ROLLIN RIDGE Filing No. 1 Grading & Erosion Control Plans El Paso County, Colorado

ROLLIN RIDGE ESTATES - FILING NO. 1

GEC PLAN
TITLE SHEET

NO.	REVISION	DATE	BY
A	COUNTY COMMENTS	2/28/20	JPS
A	COUNTY COMMENTS	5/13/20	JPS
A	COUNTY COMMENTS	7/16/20	JPS
A	COUNTY COMMENTS	9/08/20	JPS
A	POND B ACCESS REVISION	3/4/22	JPS

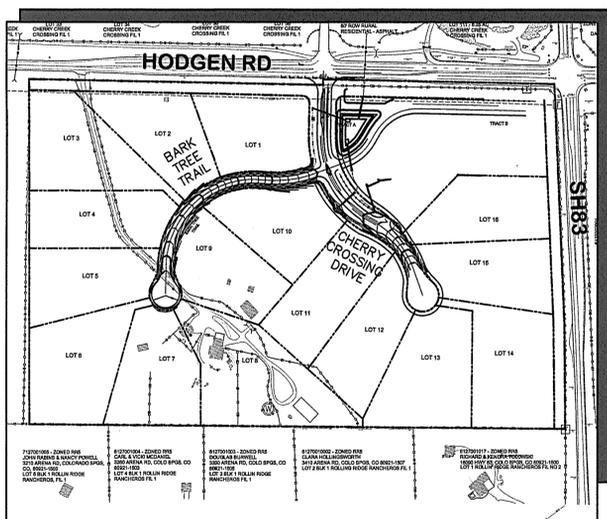
Please cloud any changes that have been made the previously approved construction plan set on all pages.
